**Town of Surfside
SPECIAL PLANNING & ZONING BOARD
AGENDA**

February 11, 2021 – 6:00 p.m.

To: Planning and Zoning Board
Thru: Andrew Hyatt, Town Manager
From: Walter Keller, PE, AICP., Town Consultant Planner
Marlin Engineering, Inc.
CC: Jason Greene, Assistant Town Manager
Lillian Arango, Town Attorney
Date February 1, 2021
RE: 9133 – 9149 Collins Avenue – Seaway Condo Acquisition LLC – Site Plan Amendment

4 LEVEL 11 PLAN - CURRENT
1/16" = 1'-0"

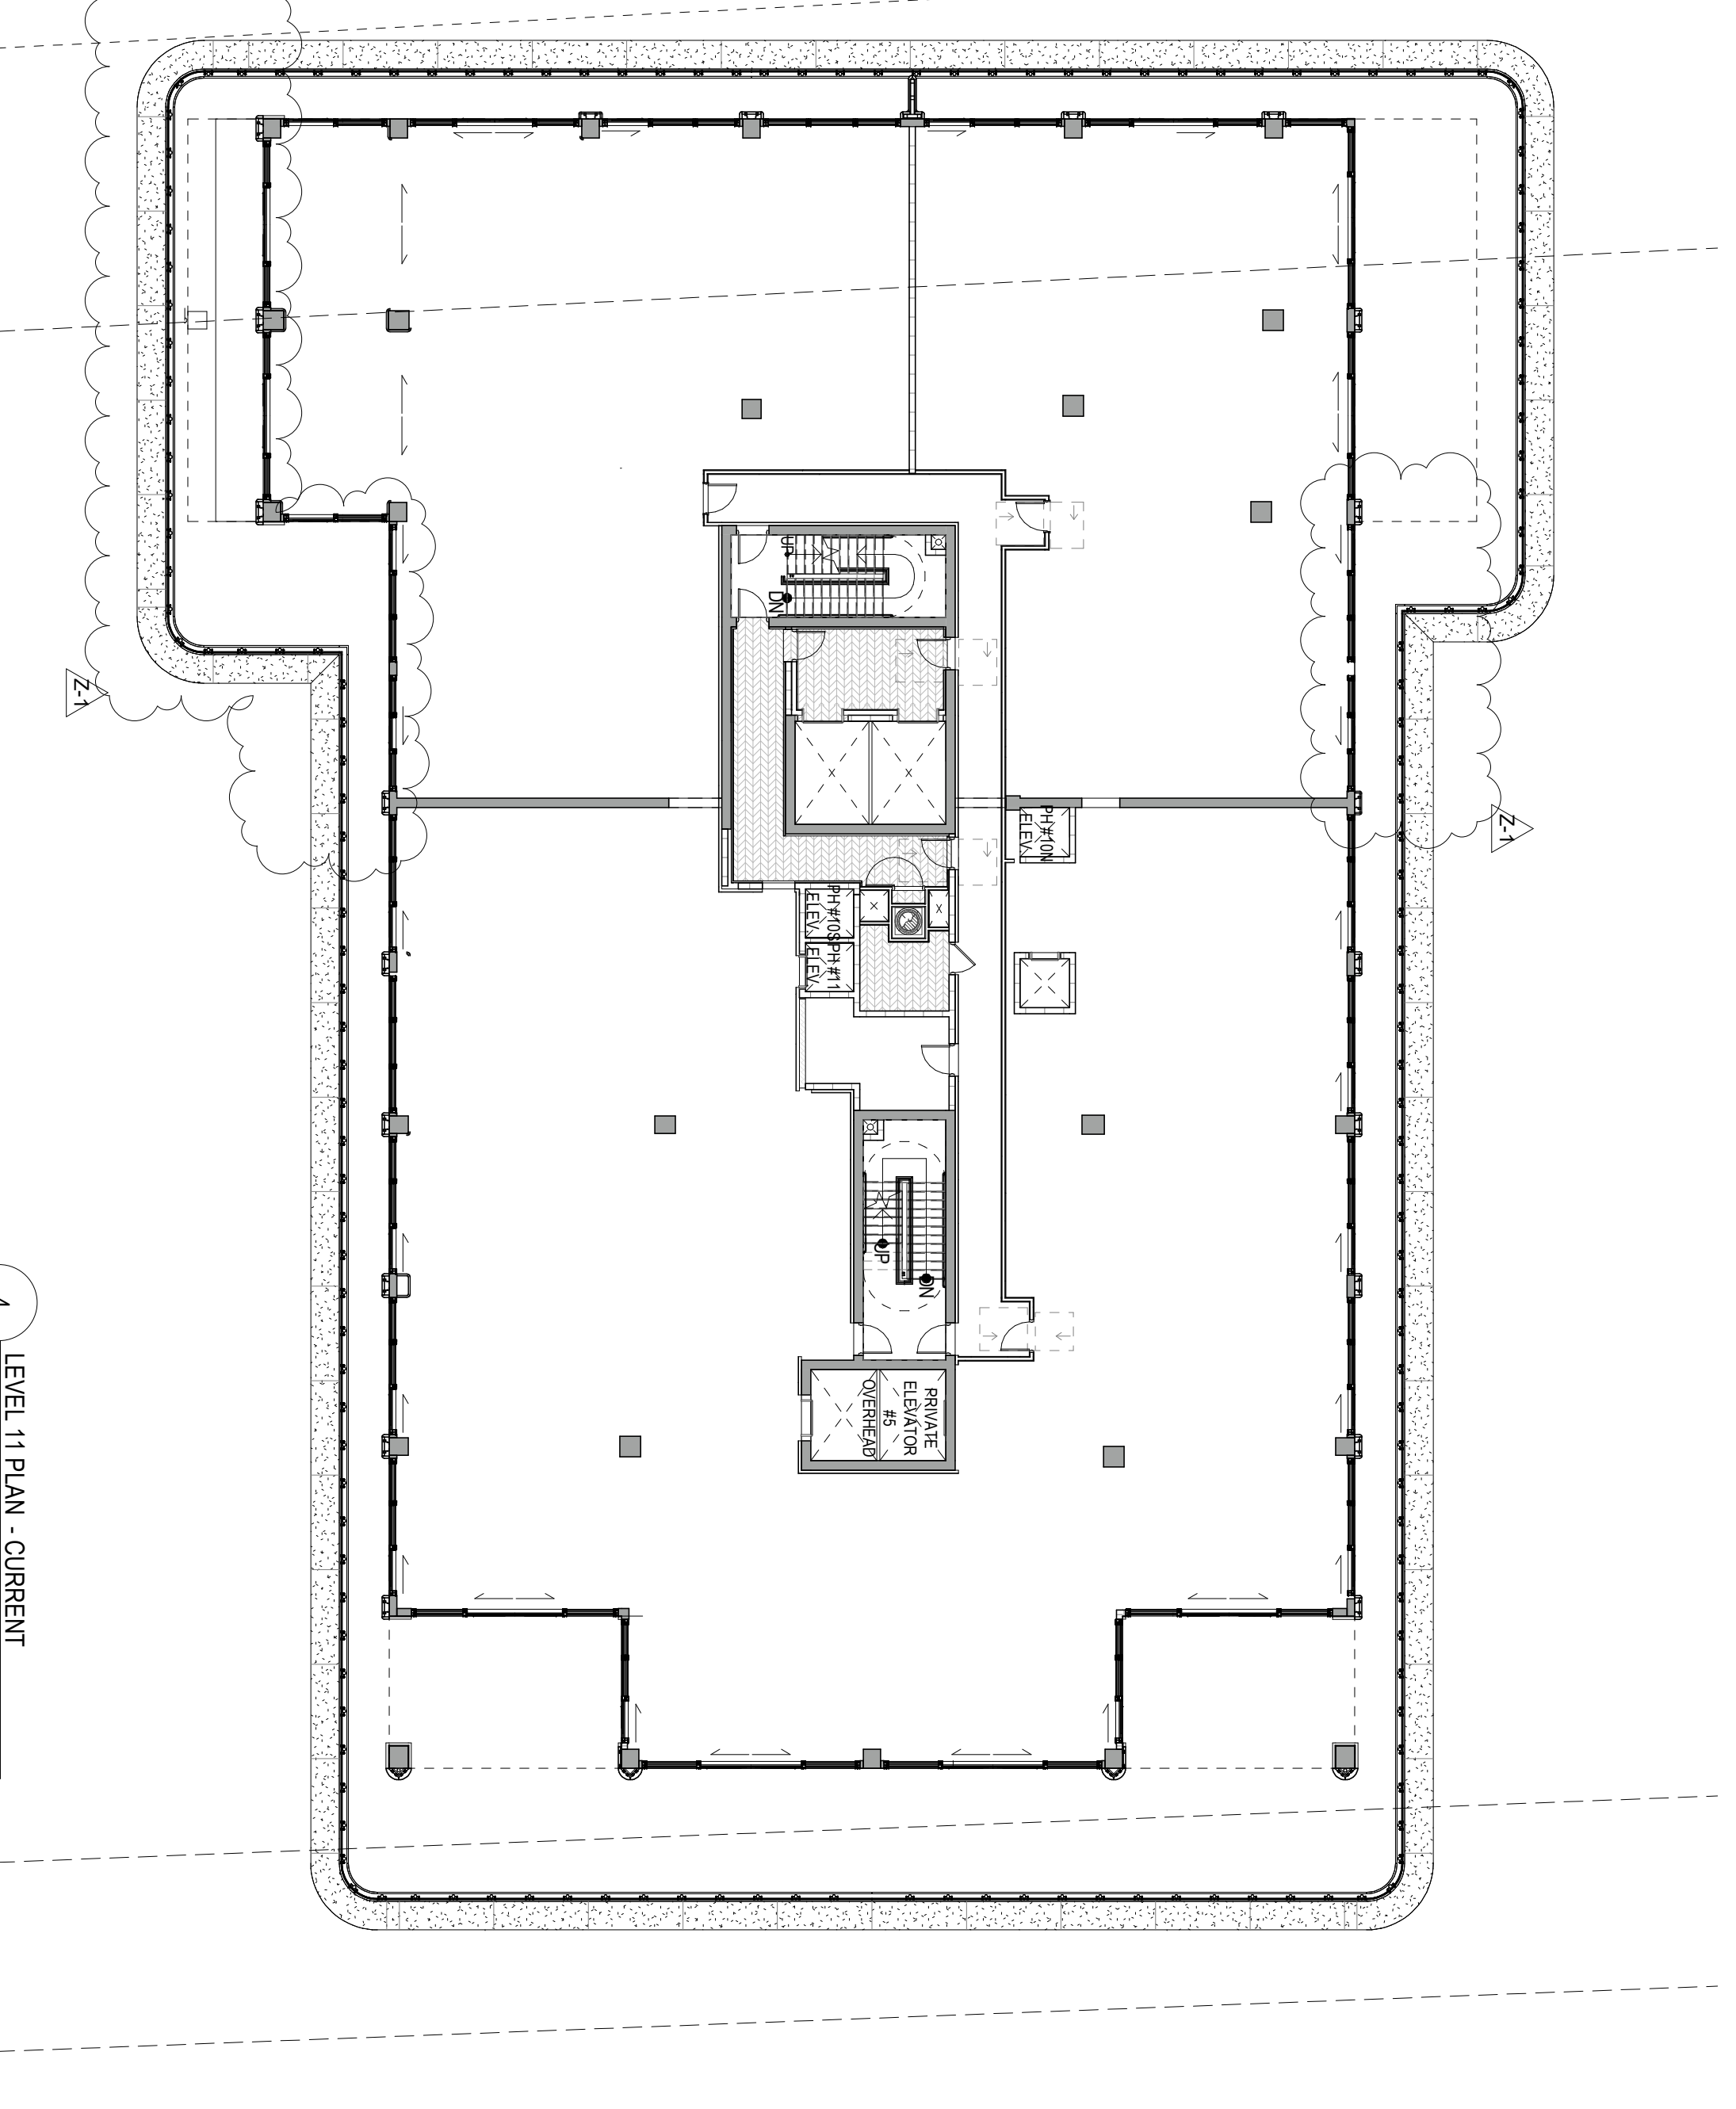
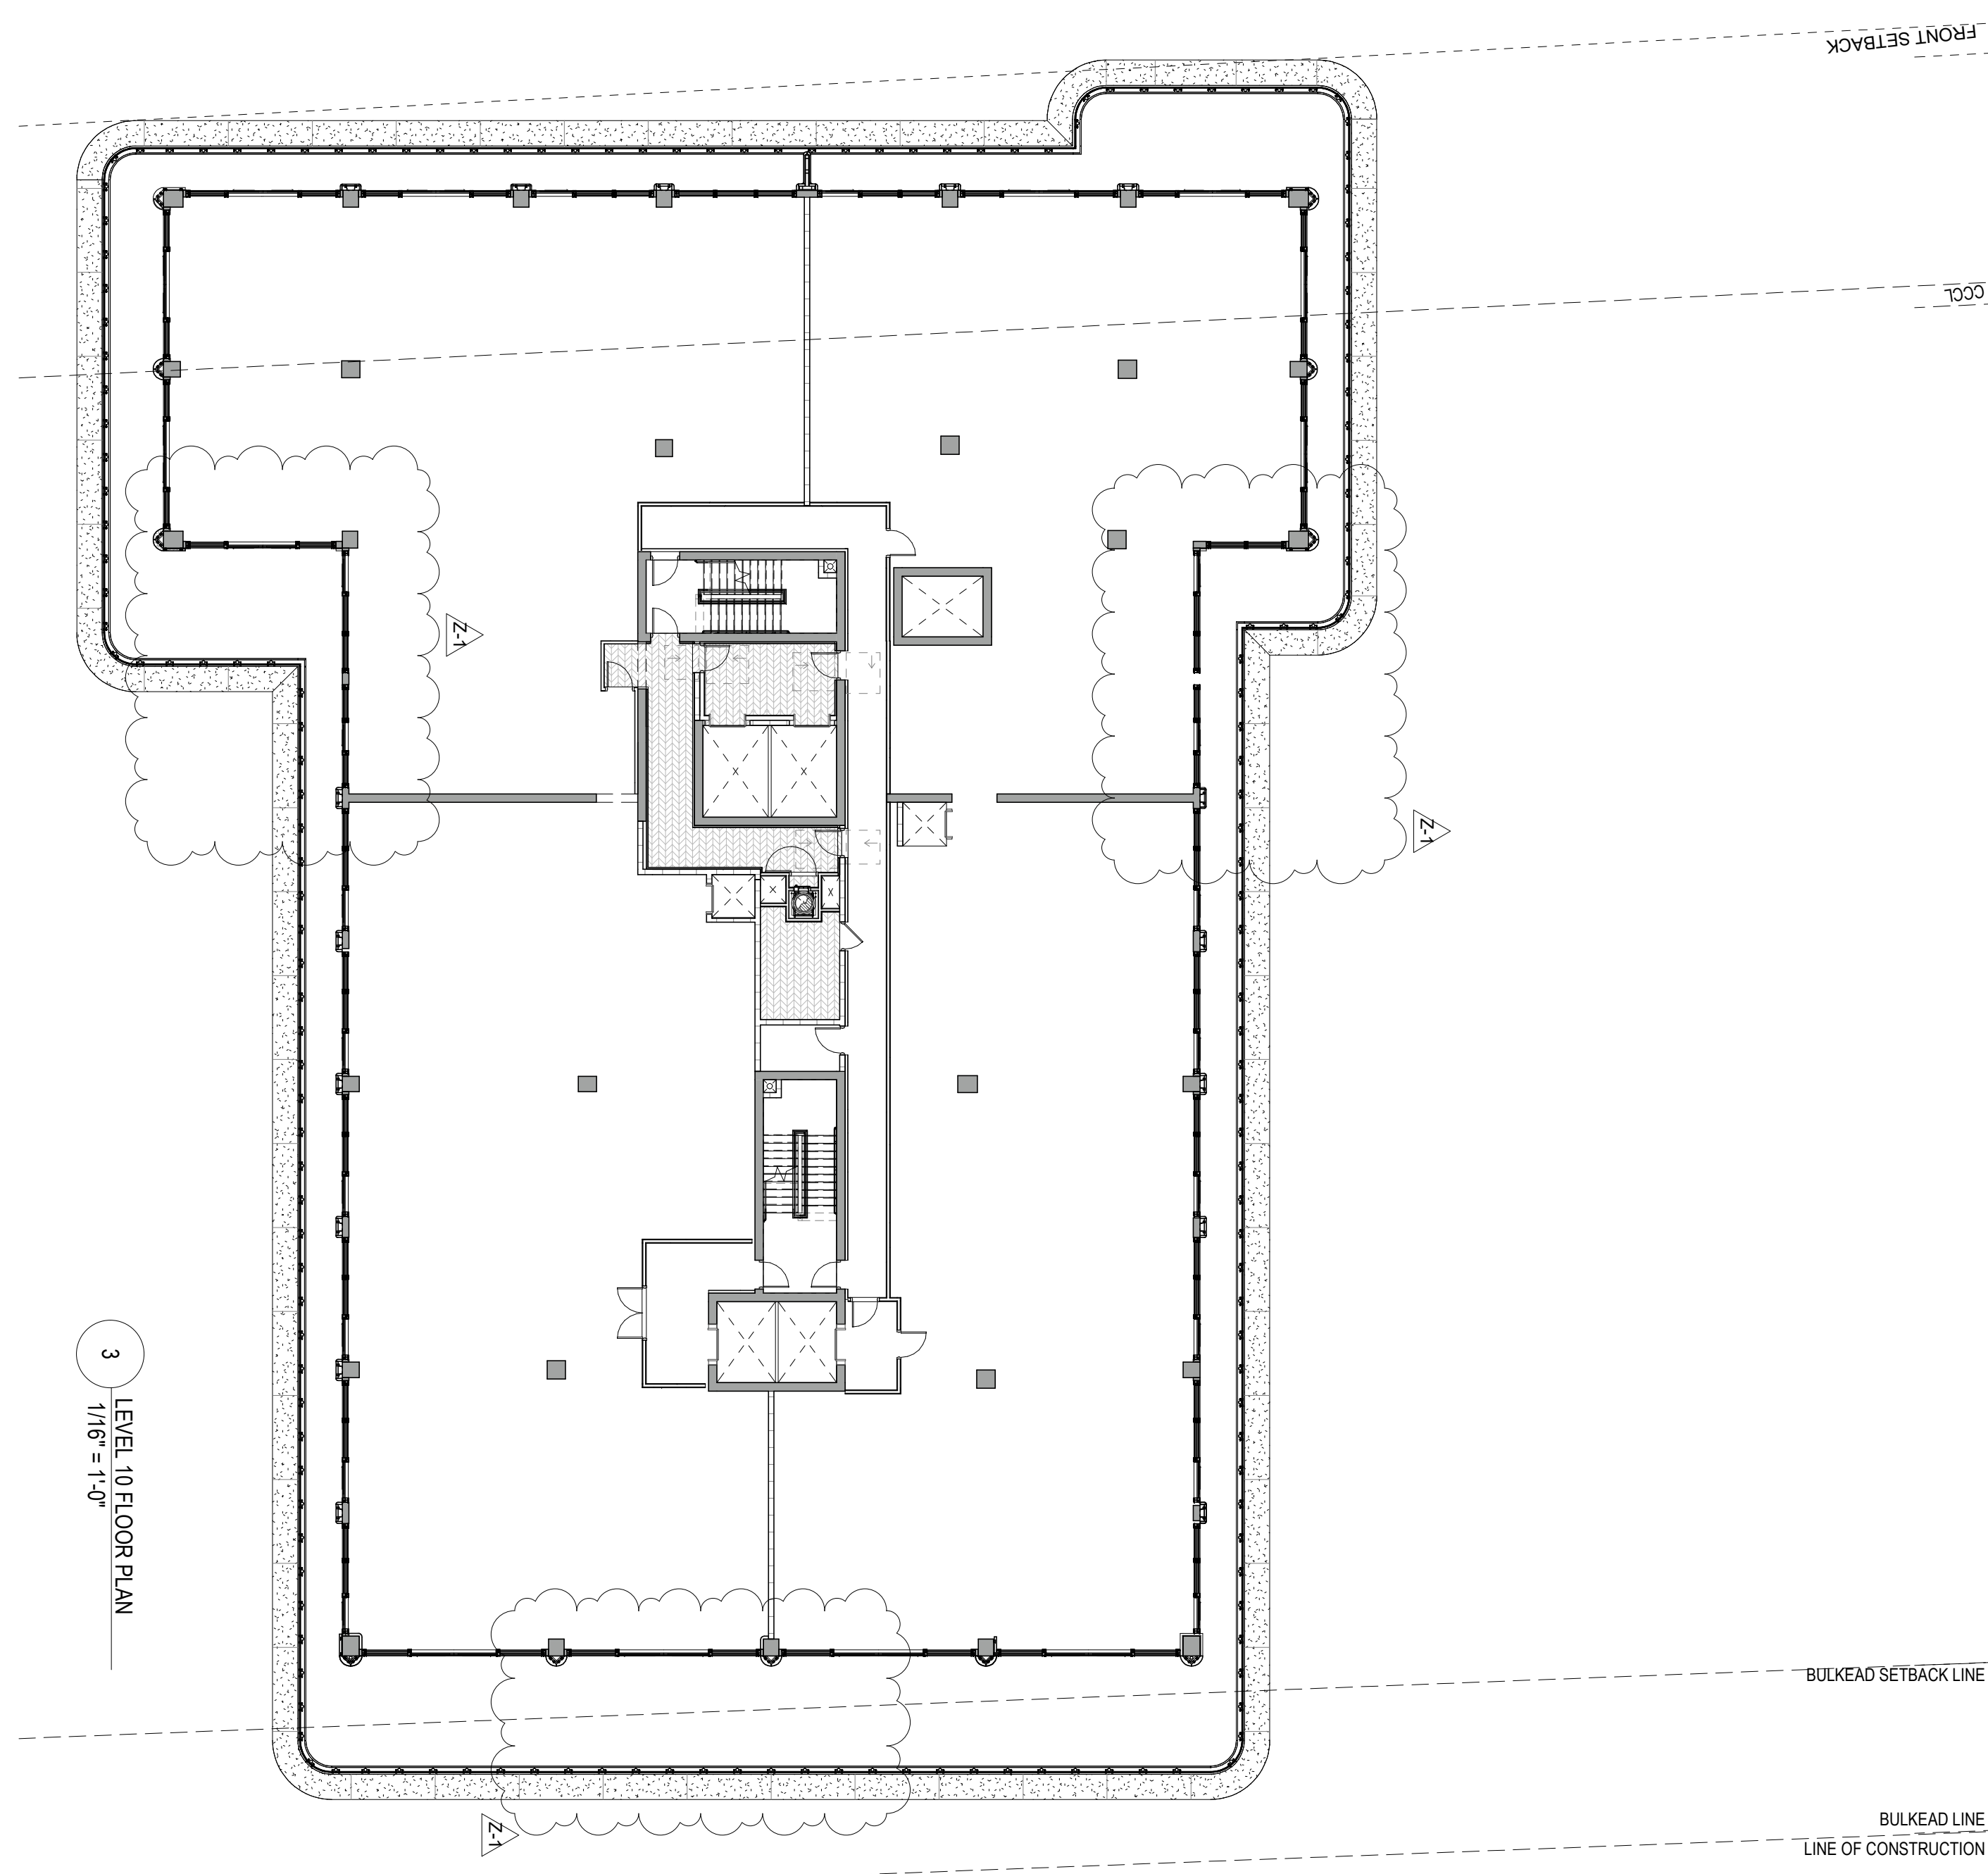
As shown on Amended Sheets A0.00, A1.03, A1.04, A1.05, A2.00, A3.00, A3.02, A4.01, and A4.02, Applicant’s new architect of record, ODP Architects, has proposed minor exterior design enhancements that include removing “notches” in balcony design on the north and south sides of levels 2 through 12; extending a balcony on the 11th level to make the design consistent with lower typical floors; and adding decorative stone louvers and balconies on the 2nd and 3rd levels to provide privacy for unit owners and hotel units. No amendments are proposed to the exterior of the historic Seaway building.
